CB ELECTRONICS LTD

| Size | Document Number | Rev |
|---|---|---|
| B | SR-MICRO-D | 1 |

Date: Wednesday, September 05, 2001 Sheet 1 of 3

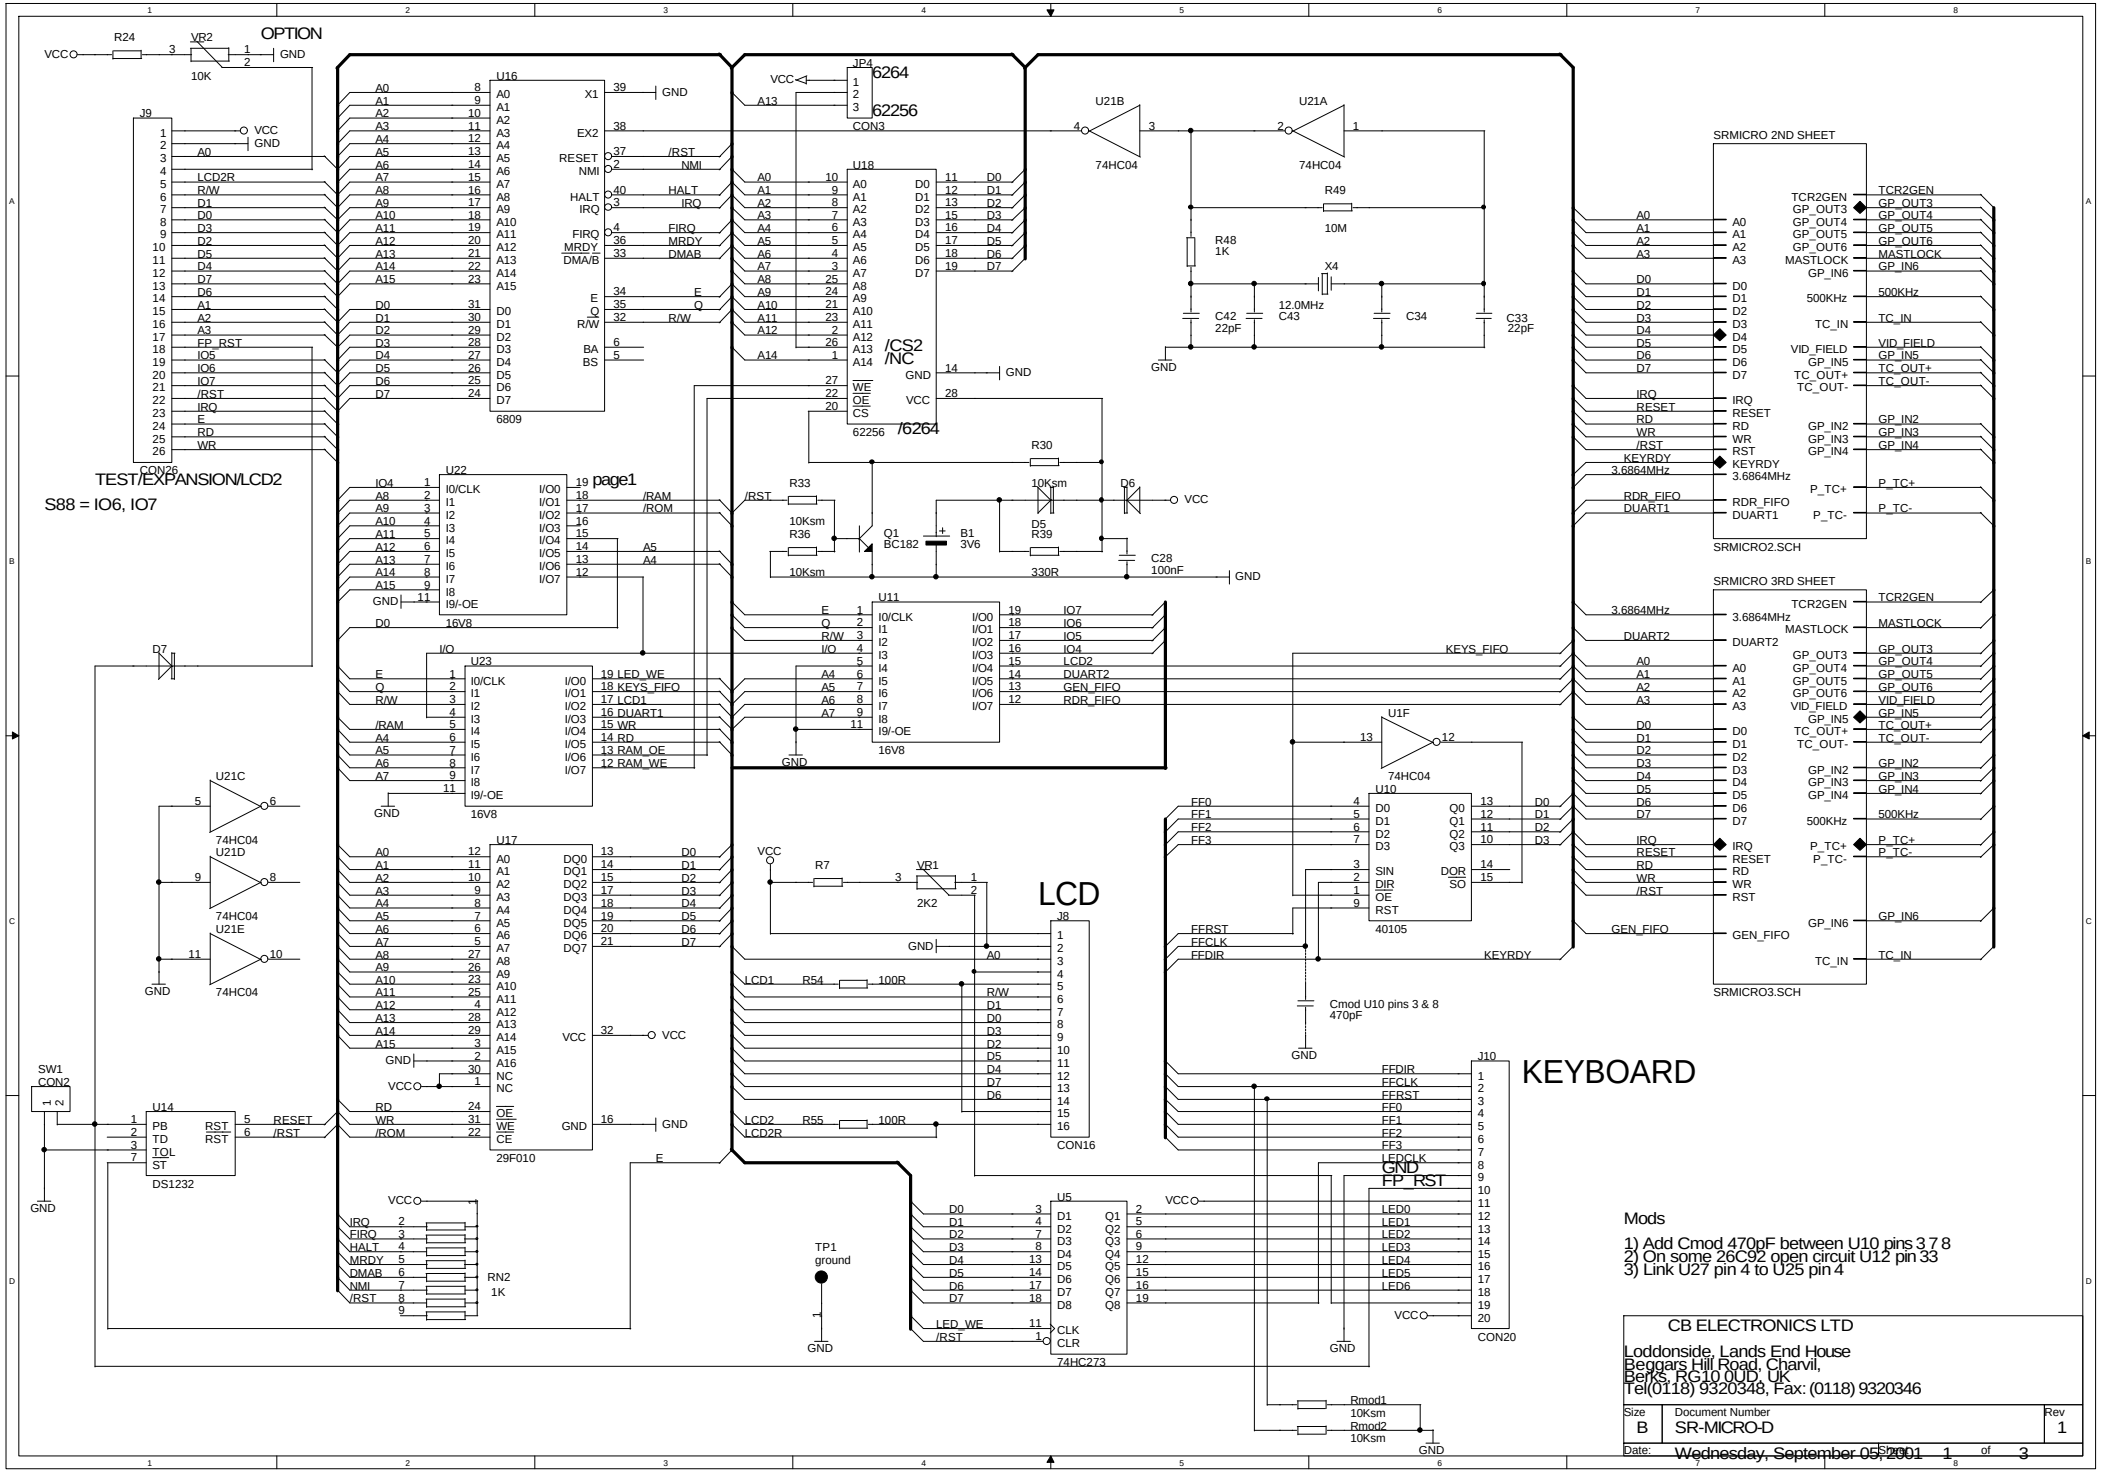
Mods

1) Add Cmod 470pF between U10 pins 3 7 8
2) On some 26C92 open circuit U12 pin 33
3) Link U27 pin 4 to U25 pin 4

| CB ELECTRONICS LTD | | |
|---|---|---|
| Size B | Document Number SRMICRO3 | Rev 1 |

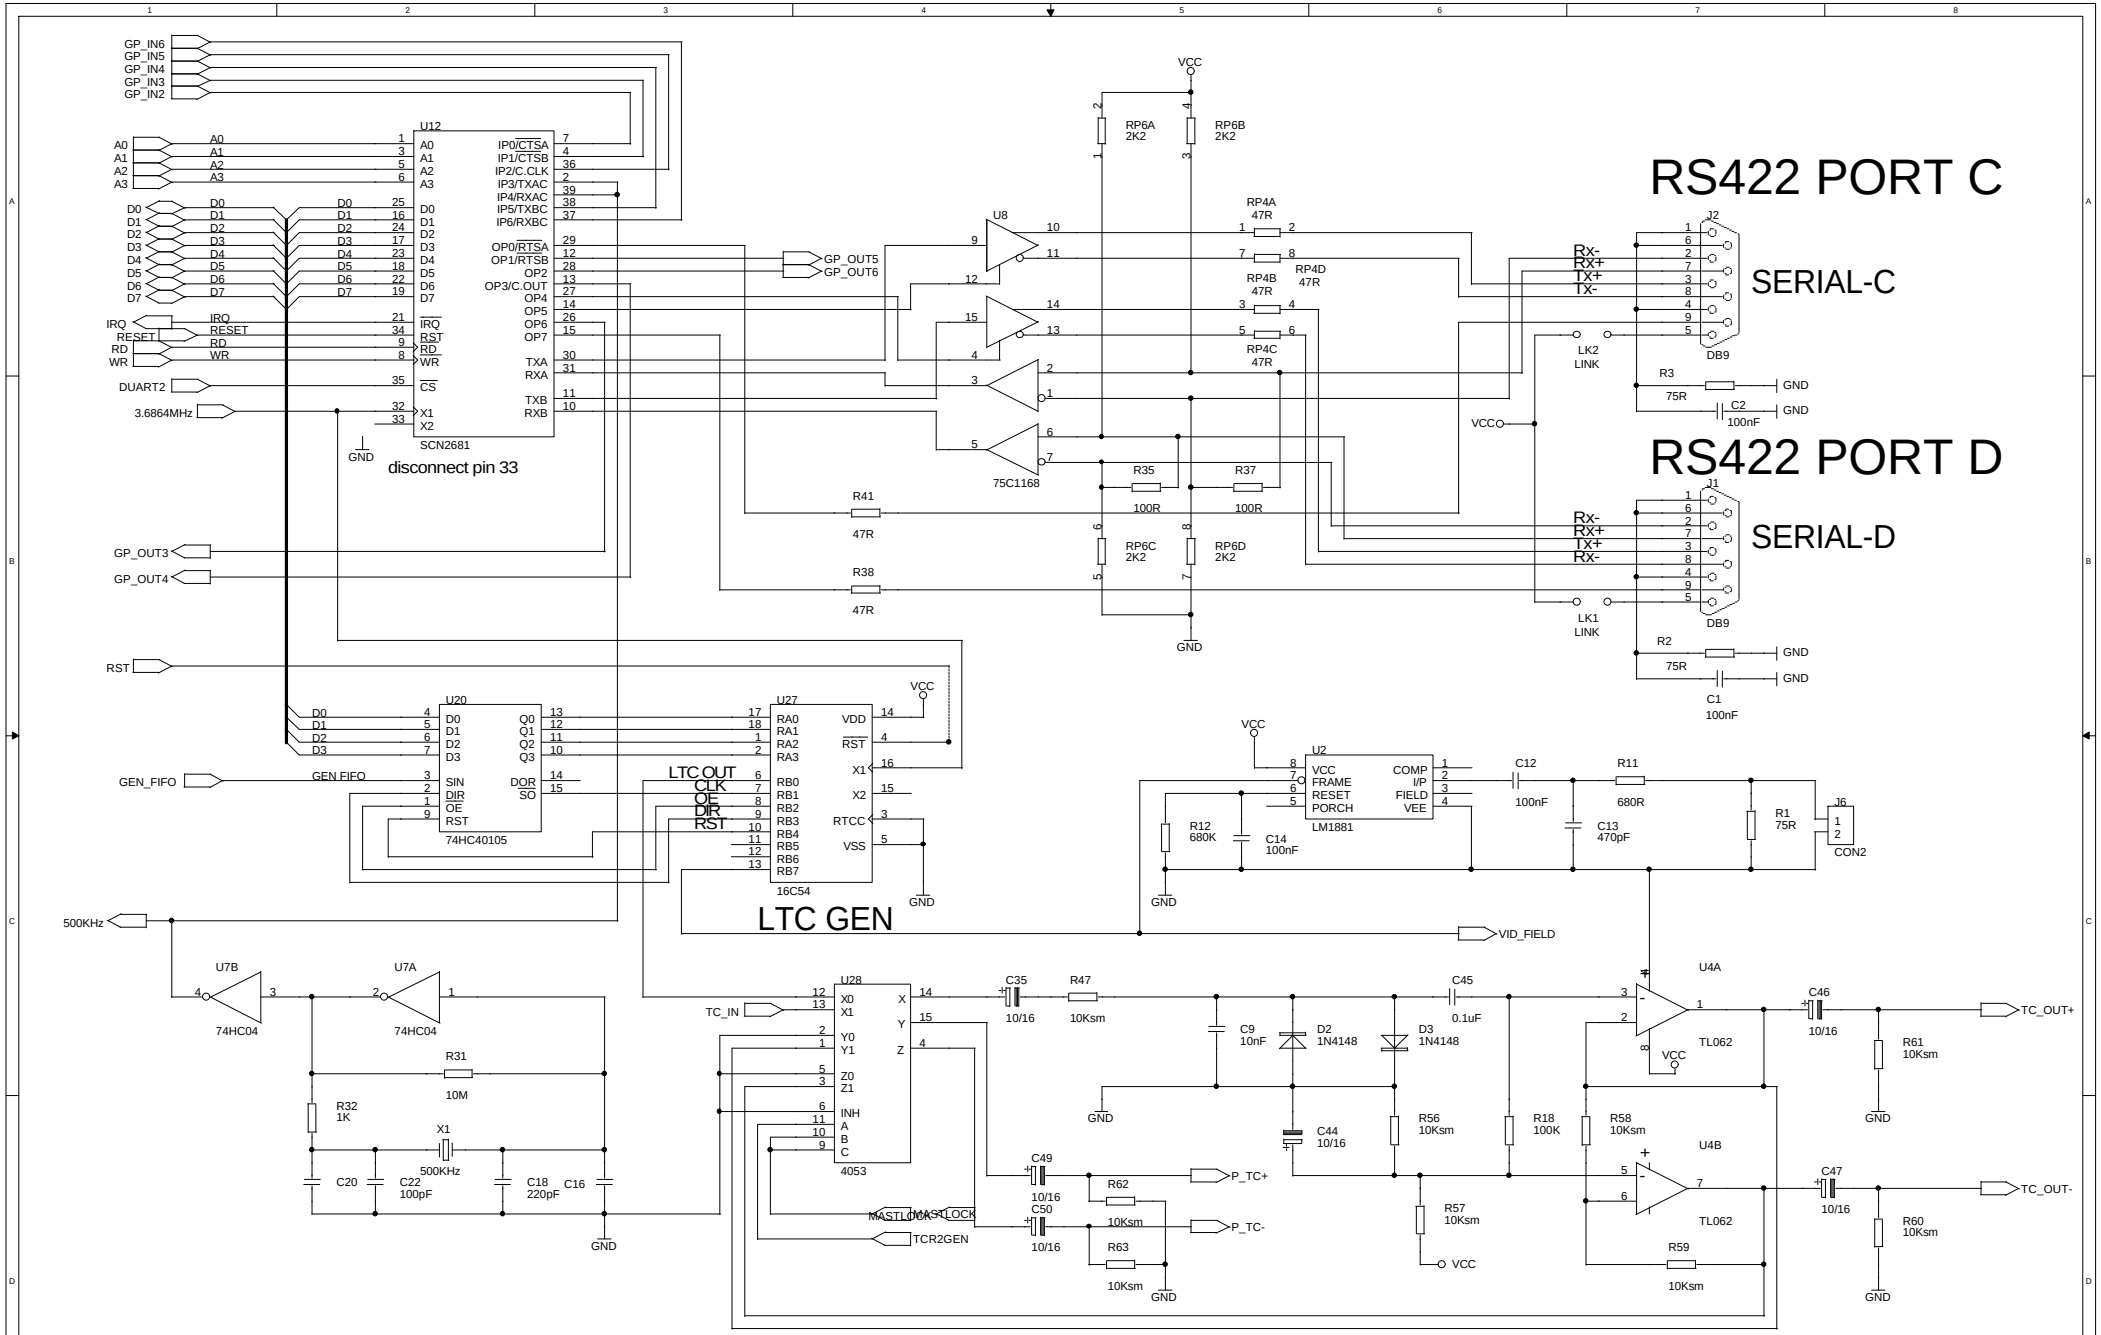
Mod: Disconnect U12 pin 33 and leave open
LINK U28 PIN4 TO U25 PIN4

check both TC_OUT+ and TC_OUT- are connected
